ADDENDUM NUMBER ONE (1)

Issuance Date: October 16, 2025

Issued by: Ashe Broussard Weinzettle Architects LLP

Project Name: Workforce Capacity and Medical Access Project
LaSalle General Hospital
Jena, Louisiana
EDA Number 08-79-05595
Architect Project Number 2024.01

1 FLOOR PLAN - PHYSICIAN'S WING - ADD ALT. #1
SCALE: 1/8" = 1'-0"

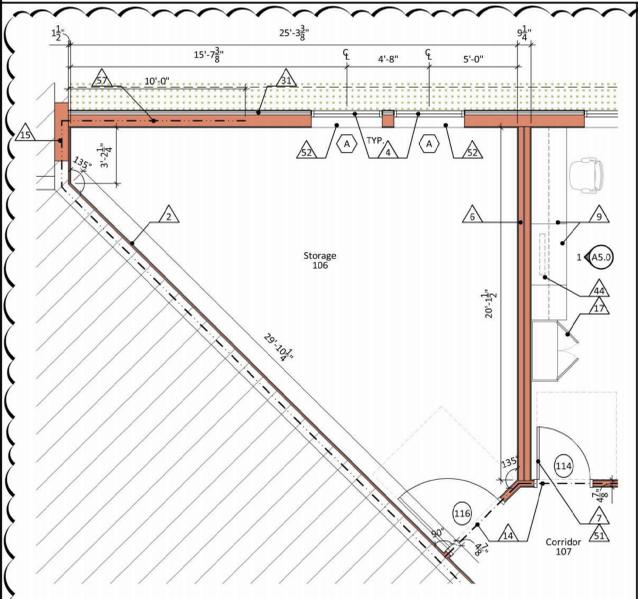
- a. 1/A2.0 Floor Plan – Physician’s Wing – Add Alt. #1
 - Identifies work associated with Additive Alternate #1 – First Floor Physician’s Wing
 - b. 2/A2.0 Storage – Enlarged Plan - Add Alt. #1

2 STORAGE - ENLARGED PLAN - ADD ALT. #1
SCALE: 1/4" = 1'-0"

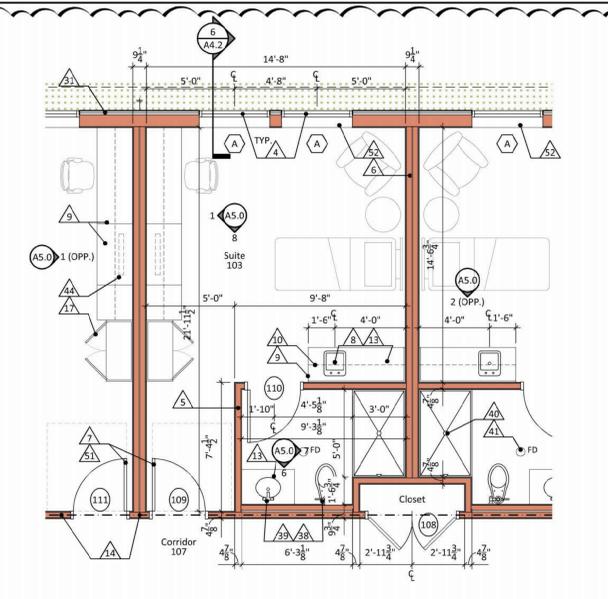
- Identifies work associated with Additive Alternate #1 – First Floor Physician’s Wing
 - c. 3/A2.0 Typical Suite 103 – Enlarged Plan – Add Alt. #1
 - Identifies work associated with Additive Alternate #1 – First Floor Physician’s Wing

1 ROOF PLAN
SCALE: 1/8" = 1'-0"

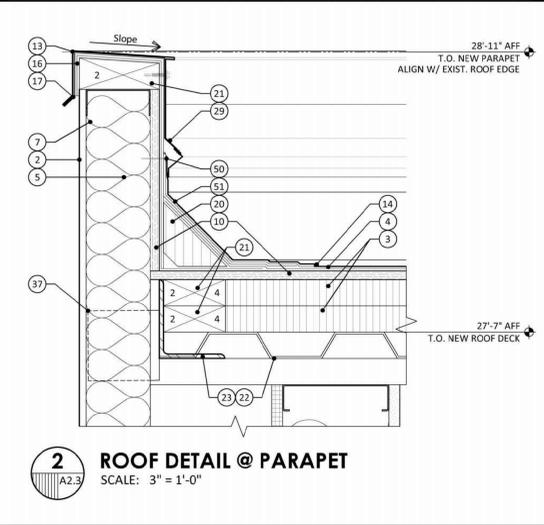
- a. 1/A2.2 Reflected Ceiling Plan – First Floor – Add Alt. #1
- 6. Drawing A2.3 ROOF PLAN & ROOF DETAILS
 - a. 1/A2.3 Roof Plan
 - Identifies work associated with Additive Alternate #1 – First Floor Physician’s Wing

3 SOUTH ELEVATION - PHYSICIAN'S WING - ADD ALT. #1
SCALE: 1/4" = 1'-0"

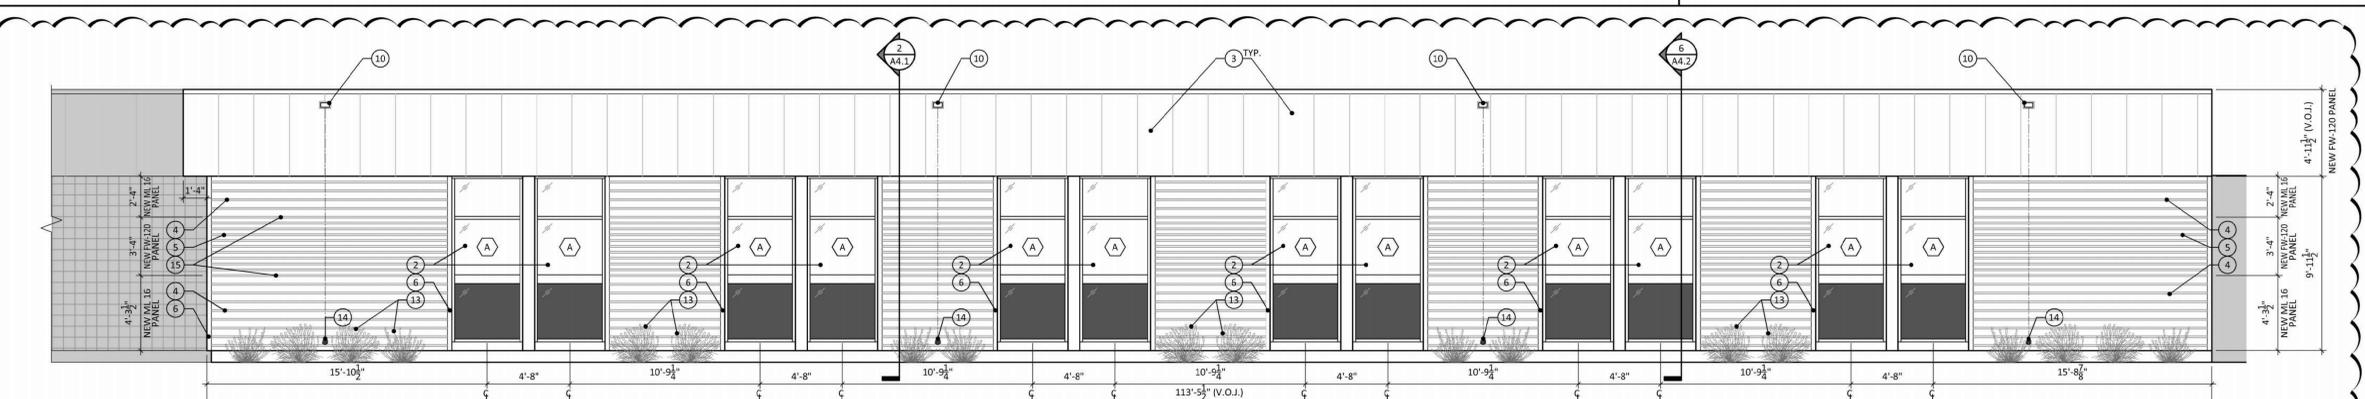
- d. Other aluminum storefront manufacturers will be considered
- 10. Drawing A3.0 EXTERIOR ELEVATIONS
 - a. 3/A3.0 South Elevation – Physician’s Wing – Add Alt. #1

5 SECTION @ PHYSICIAN'S WING - ADD ALT. #1
SCALE: 1/4" = 1'-0"

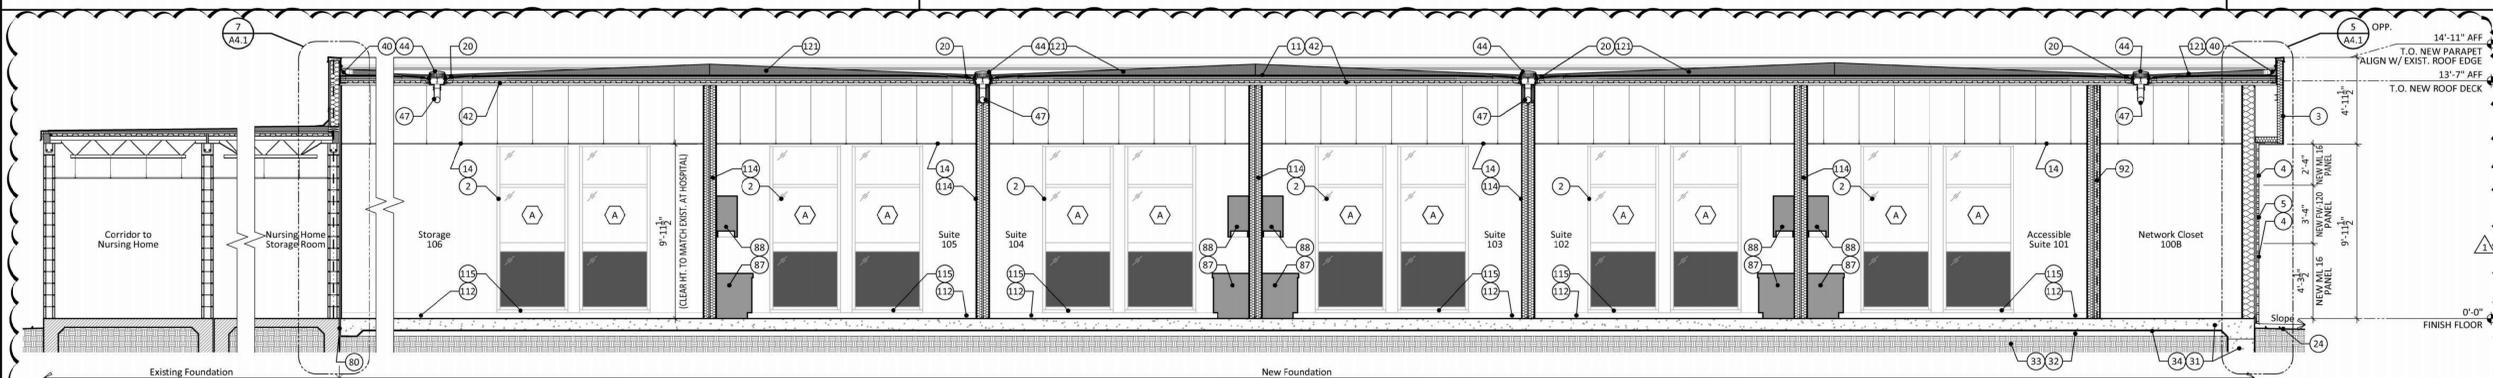
- a. 5/A4.0 Section @ Physician’s Wing – Add Alt. #1
 - Identifies work associated with Additive Alternate #1 – First Floor Physician’s Wing
- 12. Drawing A4.1 BUILDING SECTIONS & SECTION DETAILS

5 SECTION DETAIL @ PHYSICIAN'S WING - ADD ALT. #1
SCALE: 1 1/2" = 1'-0"

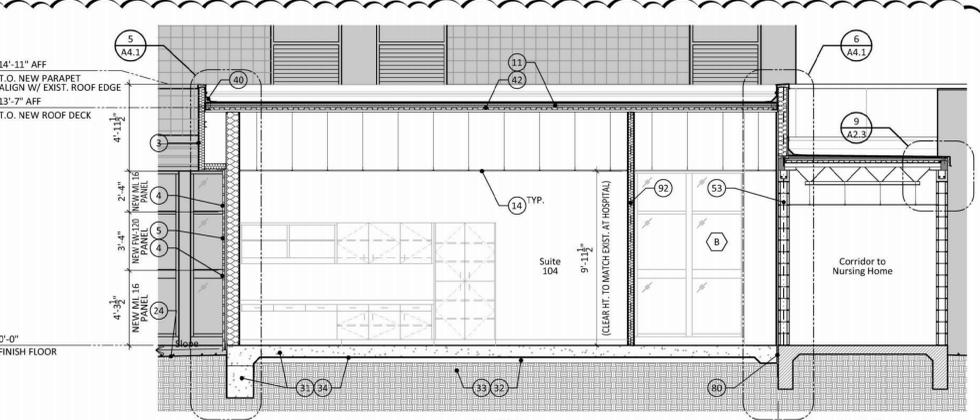
- a. 2/A4.1 Section @ Physician’s Wing – Add Alt. #1
 - Identifies work associated with Additive Alternate #1 – First Floor Physician’s Wing
 - b. 5/A4.1 Section Detail @ Physician’s Wing – Add Alt. #1

- Identifies work associated with Additive Alternate #1 – First Floor Physician’s Wing
 - c. 6/A4.1 Section Detail @ Corridor to Nursing Home & Physician’s Wing – Add Alt. #1

6 SECTION DETAIL @ CORRIDOR TO NURSING HOME & PHYSICIAN'S WING - ADD ALT. #1
SCALE: 1 1/2" = 1'-0"

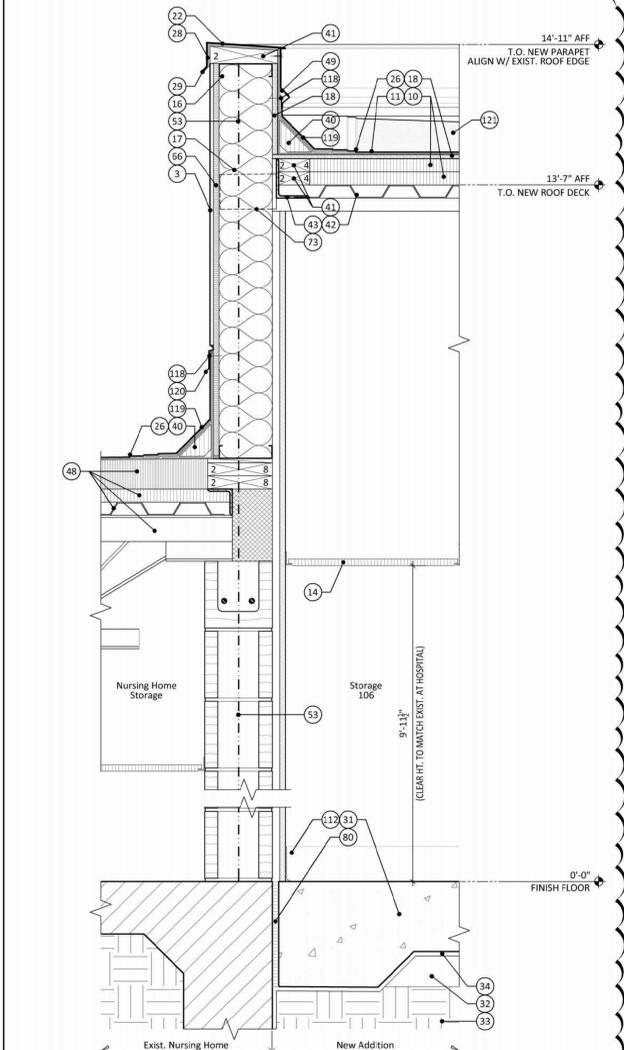
- Identifies work associated with Additive Alternate #1 – First Floor Physician’s Wing
 - d. 7/A4.1 Section Detail @ Nursing Home & Physician’s Wing – Add Alt. #1

7 SECTION DETAIL @ NURSING HOME & PHYSICIAN'S WING - ADD ALT. #1
SCALE: 1 1/2" = 1'-0"

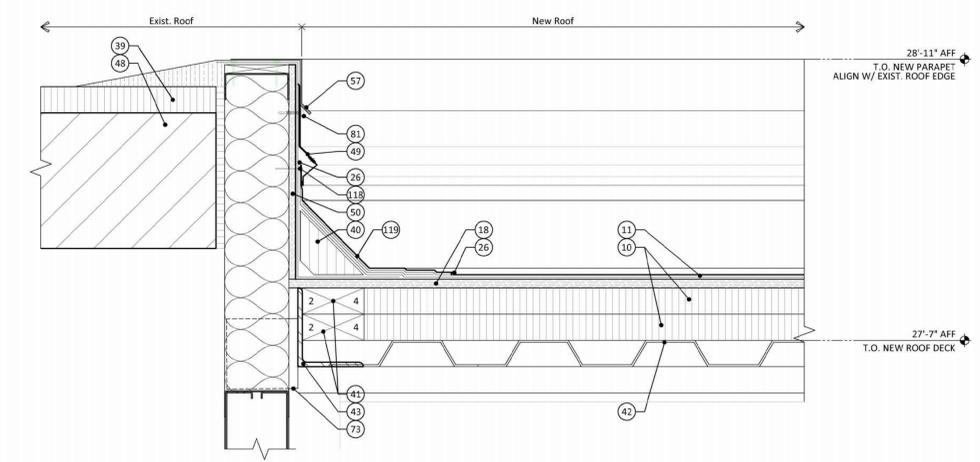
- Identifies work associated with Additive Alternate #1 – First Floor Physician’s Wing
- 13. Drawing A4.2 SECTION DETAILS
 - a. 6/A4.2 Section Detail Through Window Sill – Add Alt. #1

1
ACCESSIBLE SUITE 101 -
ADD ALT. #1
SCALE: 1/4" = 1'-0"

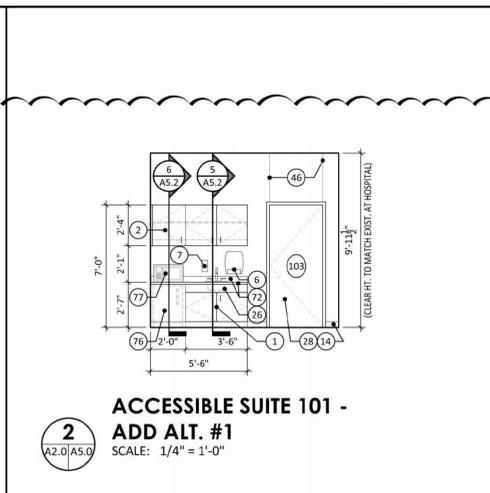
- Identifies work associated with Additive Alternate #1 – First Floor Physician’s Wing
- 14. Drawing A5.0 INTERIOR ELEVATIONS
 - a. 1/A5.0 Accessible Suite 101 – Add Alt. #1

- Identifies work associated with Additive Alternate #1 – First Floor Physician’s Wing
 - b. 2/A5.0 Accessible Suite 101 – Add Alt. #1
 - Identifies work associated with Additive Alternate #1 – First Floor Physician’s Wing

LASALLE GENERAL HOSPITAL		project no. 2024.01
Workforce Capacity and Medical Access Project		drawn by EM
EDA No. 08-79-05595		checked by CC
187 Ninth St. Jena, Louisiana 71342		project date JAN 2025
Email: adginc@adginc.org		sheet contents
MECHANICAL PLAN - PHYSICIAN'S WING		drawing no. M2.0R1

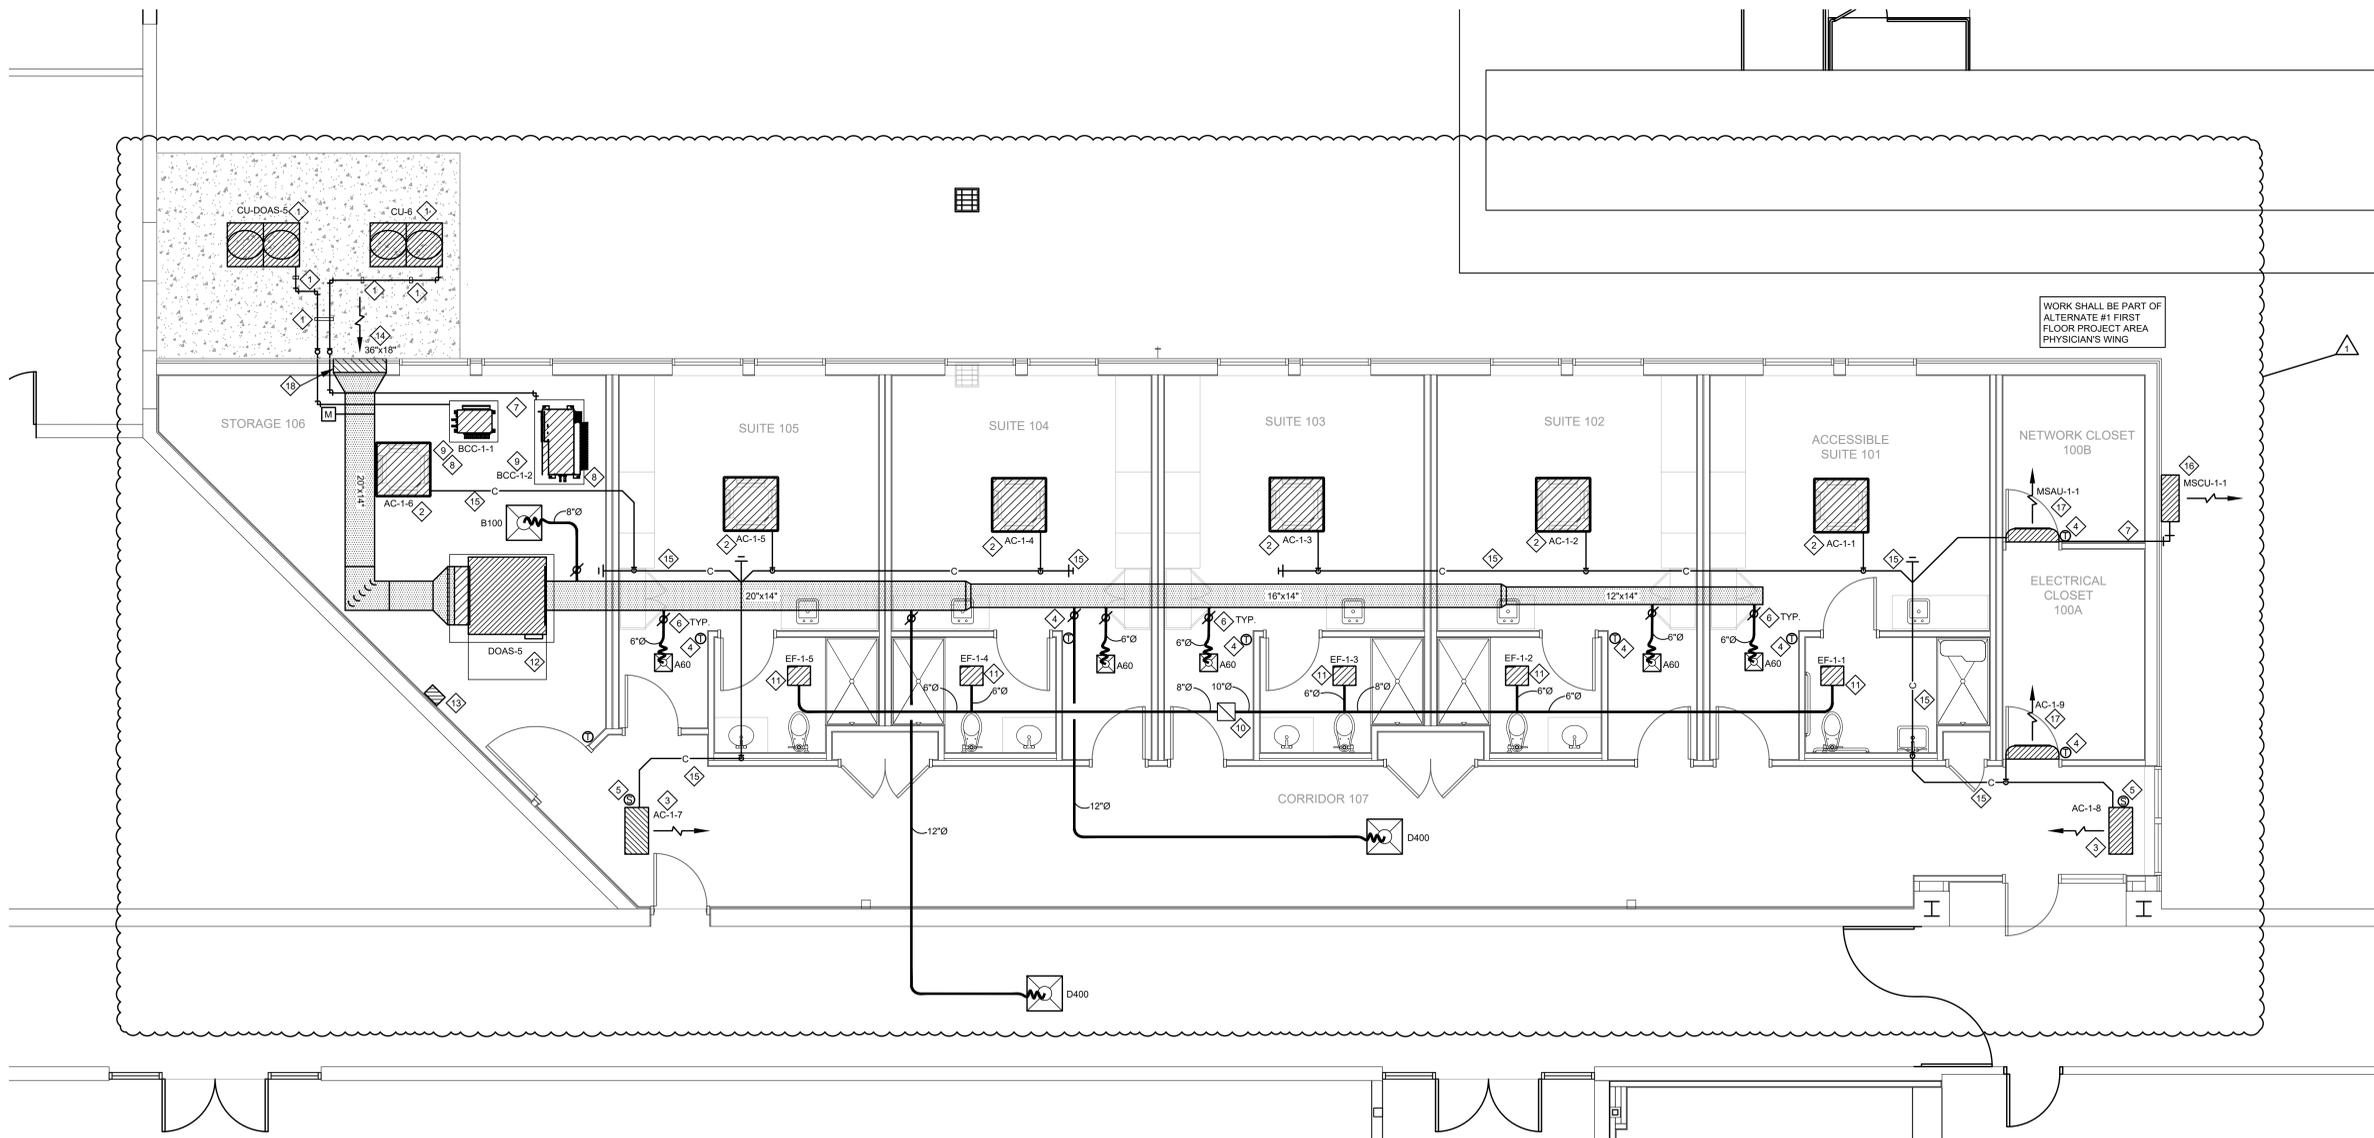
1. Drawing M2.0R1
 - a. Replace M2.0 in its entirety with the attached M2.0R1. Changes to plan are clouded for reference.
2. Drawing M2.1R1
 - a. Replace M2.1 in its entirety with the attached M2.1R1. Changes to plan are clouded for reference.
3. Drawing M2.2R1
 - a. Replace M2.2 in its entirety with the attached M2.2R1. Changes to plan are clouded for reference.
4. Drawing M3.0R1
 - a. Replace M3.0 in its entirety with the attached M3.0R1. Changes to plan are clouded for reference.
